Subject: Request for Enforcement Discretion and Supplement to Proposed License Amendment Request
Cooper Nuclear Station, NRC Docket 50-298, DPR-46

REQUEST FOR ENFORCEMENT DISCRETION FROM THE REQUIREMENTS
OF CNS TECHNICAL SPECIFICATION 3.7.3

RESPONSE TO NRC VERBAL QUESTIONS

Figure 1, Rev. 11

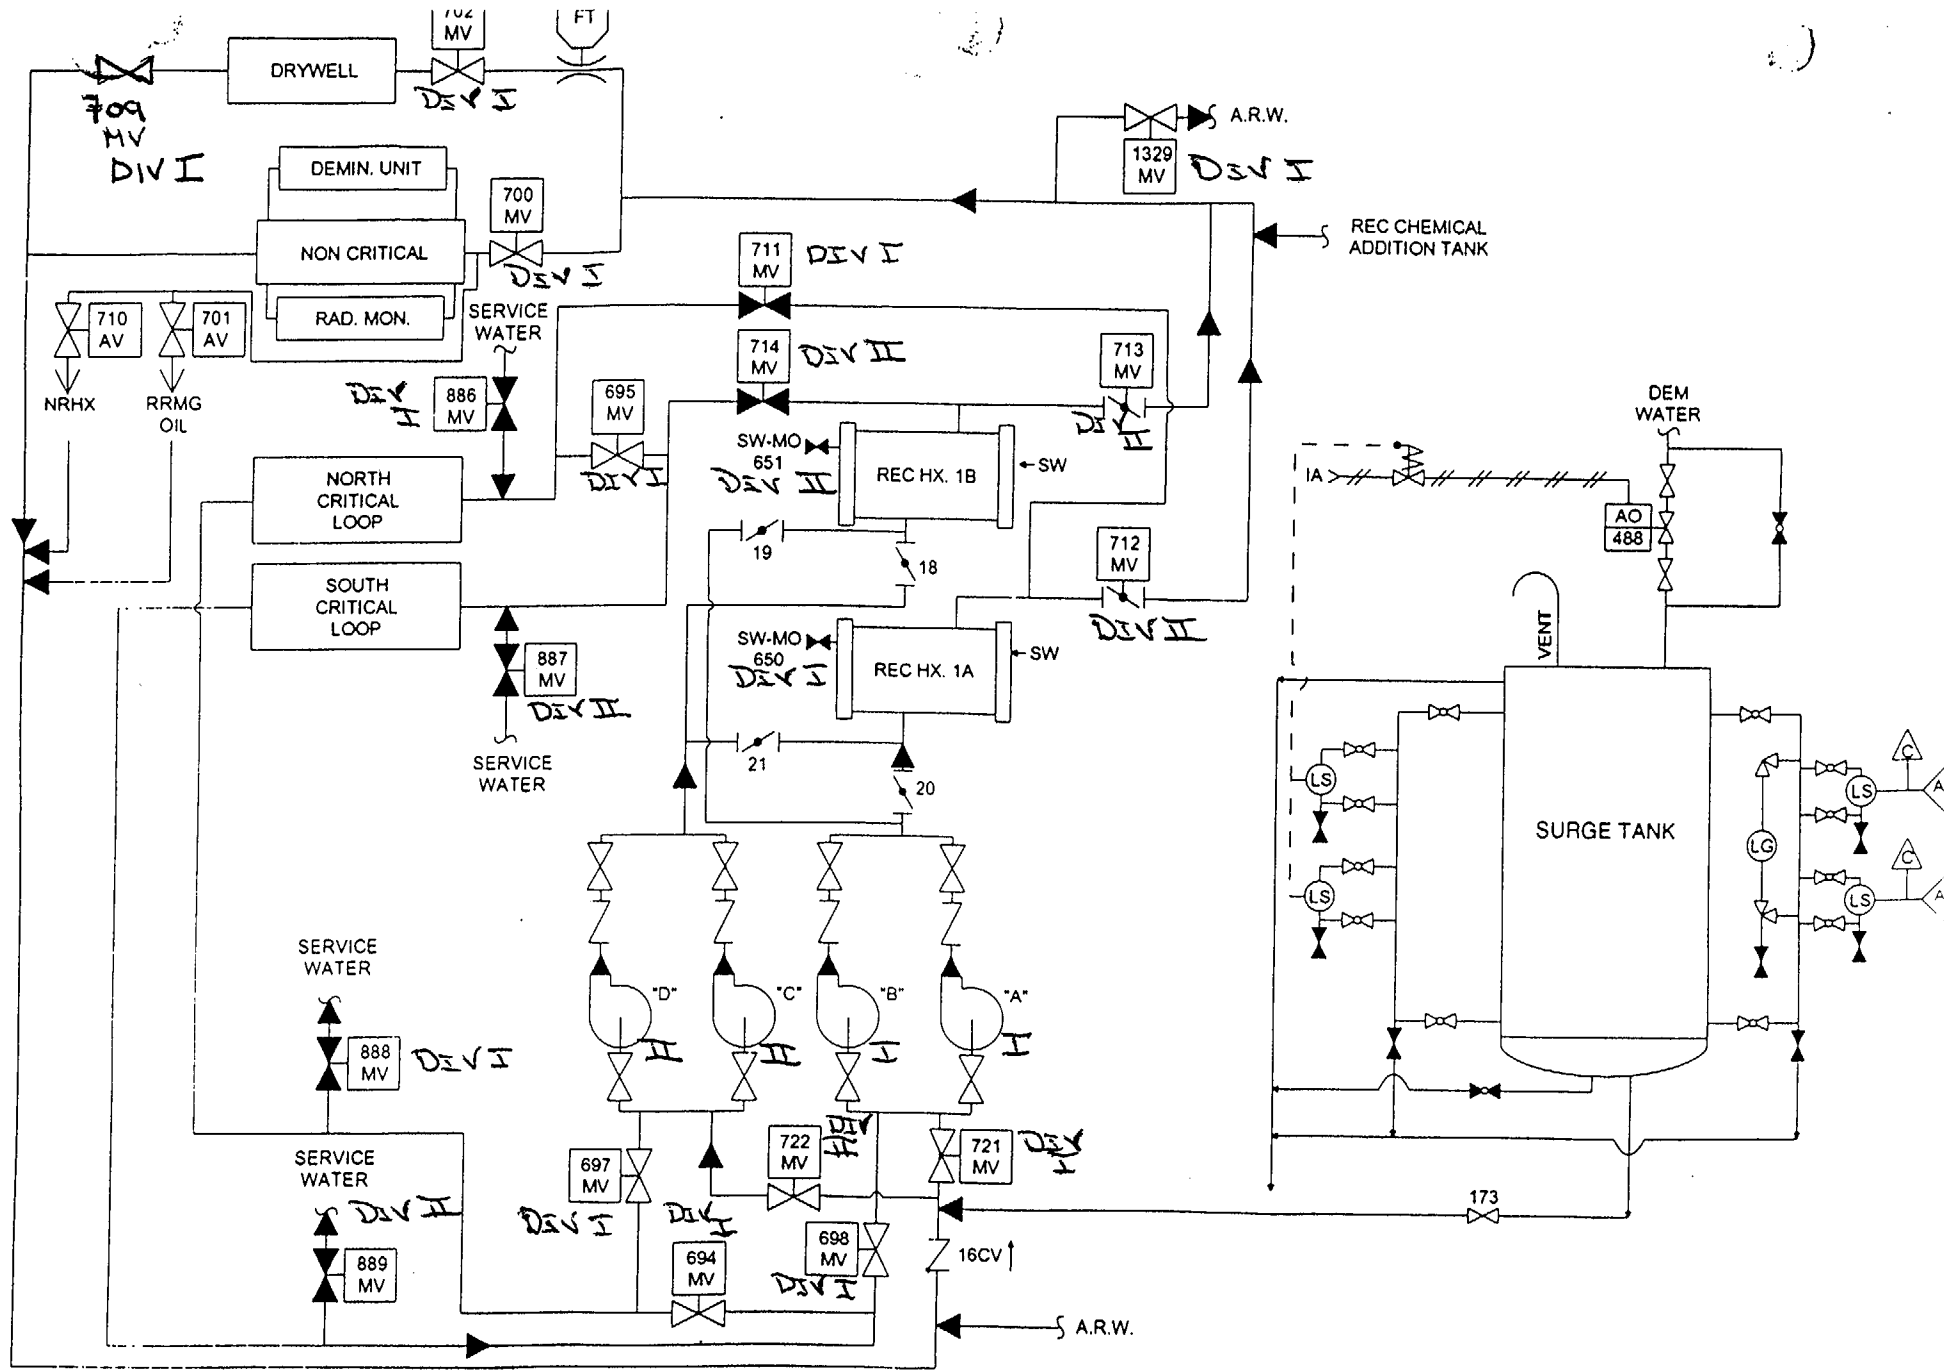
In a teleconference between J. Sumpter, et. al., (NPPD) and L. Burkhart, et. al., (NRC) on November 9, 1999, the NRC identified a postulated single failure vulnerability associated with the Amendment request contained in NLS99050. In a teleconference between NRC and NPPD personnel on January 1, 2000 additional questions were raised. This attachment provides the responses to the NRC questions raised in these teleconferences. Figure 1 provides an updated simplified diagram of the Reactor Equipment Cooling System. This figure includes annotation of the divisional power supply for each pertinent valve.

In a teleconference between J. Sumpter, et. al., (NPPD) and L. Burkhart, et. al., (NRC) on November 9, 1999, the NRC identified a postulated single failure vulnerability associated with the Amendment request contained in NLS99050. This single failure vulnerability involved the potential to divert the Service Water backup flow away from the Reactor Equipment Cooling critical loops via the non-critical drywell loop and a resultant flow being established through the surge tank vent. The District has completed an evaluation of this scenario and concluded that the postulated event can be accommodated by the existing REC system design. The supply valves to the drywell non-critical header, and two other non-critical headers (REC-MOV-700MV, -702MV, and -1329MV) are supplied motive and control power from Division I. The discharge valves from the heat exchangers (REC-MOV-712MV and -713MV) are supplied motive and control power from Division II. With isolation valves from both Division I and Division II in the flow path to the non-critical headers, there is no credible single failure which could prevent the isolation of the non-critical headers. The District acknowledges that the Figure provided in the original Amendment Request would have led the NRC to ask about this particular single failure.

A question was asked relative to the impact of the non-critical loop header isolation valves leak-tightness on the operability of the REC System if a leak develops in the non-critical header. Specifically, how can the required seven-day inventory in the Surge Tank be guaranteed if we do not have a leak free seal in the non-critical loop header isolation valves.

Low pressure in the common discharge header signals an alarm in the main control room and automatically closes the Division I motor-operated valves in the supply headers to the non-safety-related-services. This action is initiated by a pressure switch which will send a signal to close MO-700MV, MO-702MV, and MO-1329MV when low pressure is sensed.

nonessential services. This action is initiated by a pressure switch in each heat exchanger's outlet which will send a signal to close MO-712MV if a low pressure condition is sensed in the 'A' heat exchanger outlet, and MO-713MV if a low pressure condition is sensed in the 'B' heat exchanger outlet.

Presently, REC system operability is determined based on total system leakage. There is no distinction between leakage rates in the critical or non-critical headers. Once total system leakage reaches a rate that indicates the system cannot operate for a minimum of seven days without make up water, the actions of TS LCO 3.7.3 will be performed. Since the operability of the system is determined on total system leakage, the position of the non-critical header isolation valves have no impact on ensuring the required seven day inventory is maintained in the surge tank.

The non-critical header isolation valves are required to isolate a potential flow path to the REC Surge Tank (which is vented to the Reactor Building atmosphere) during the Large Break LOCA scenario if the SW system back-up is required to be initiated following postulated equipment failures. A small leakage rate through these valves has no impact on the ability of the REC System to supply 7 days of cooling water without inventory makeup or the ability of the SW system to provide the required cooling flow through the REC critical headers.
